## RE: MP10\_0198- Channel 9 site- Preferred Project Report

Council has reviewed the Preferred Project Report (PPR) for the Channel 9 site, Artarmon Road, Willoughby. Council made a submission dated 15 May 2013 (Attachment 1) to the Environmental Assessment Report (EAR) which outlined a number of major concerns with the original concept plan proposal.

#### WILLOUGHBY CITY COUNCIL SUBMISSION TO MP10\_0198- CHANNEL 9 PART 3A CONCEPT PLAN APPLICATION

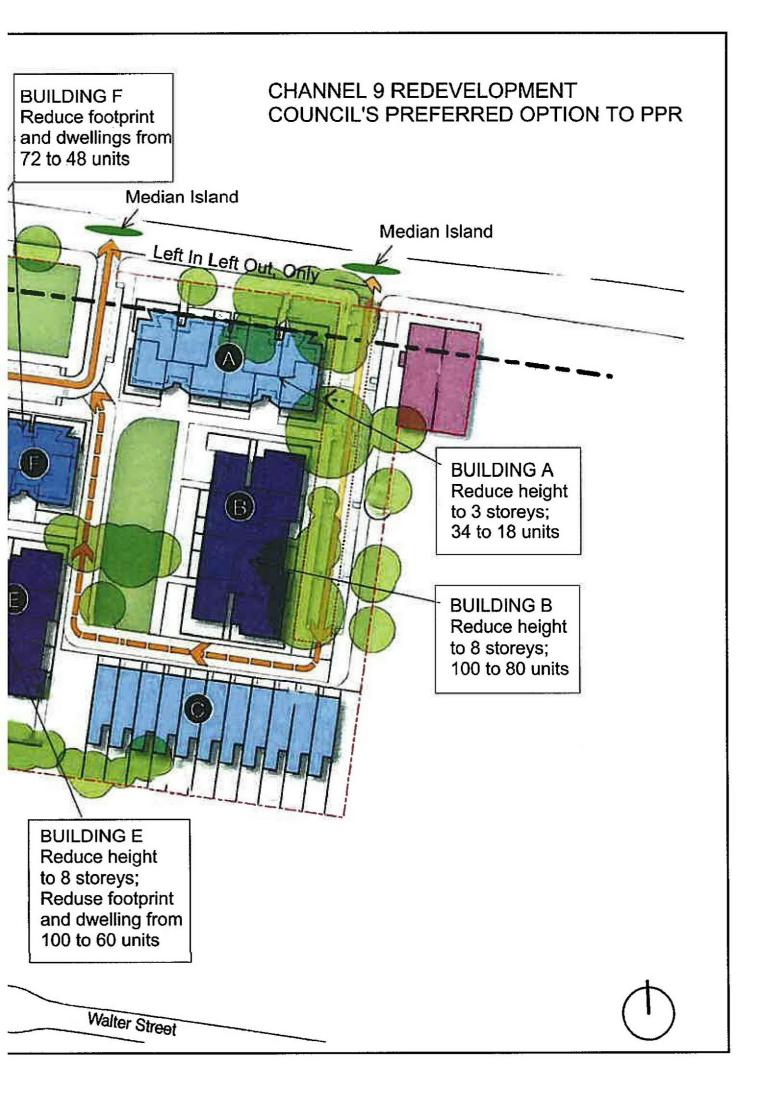
Council recognises that the site is suitable for medium density residential development, consistent with the most densely developed site in the local area- the adjacent Castle Vale development which is 1:1 and has a maximum height of 27 metres.

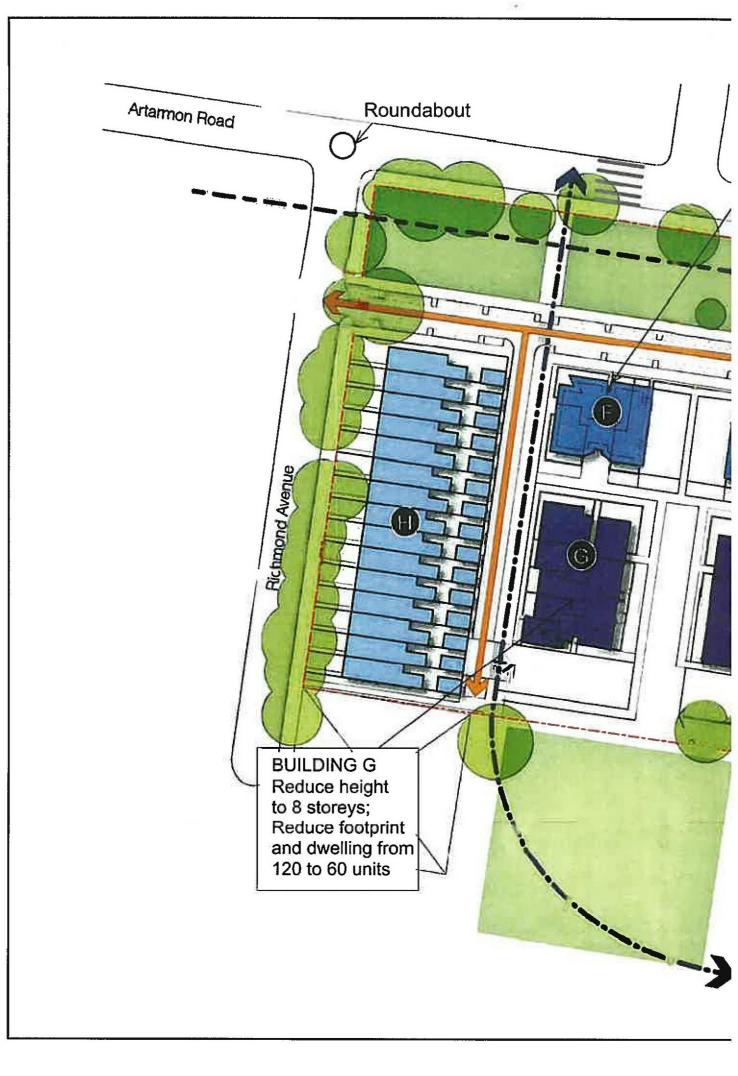
Council's alternative proposal for the site provides for 300 dwellings, a better urban design outcome and amenity both for future on-site residents and for the neighbouring residents and Conservation Area.

Council is prepared to support a revised scheme that incorporates the following matters, a revised Statement of Commitments and terms of approval as outlined in the submission.
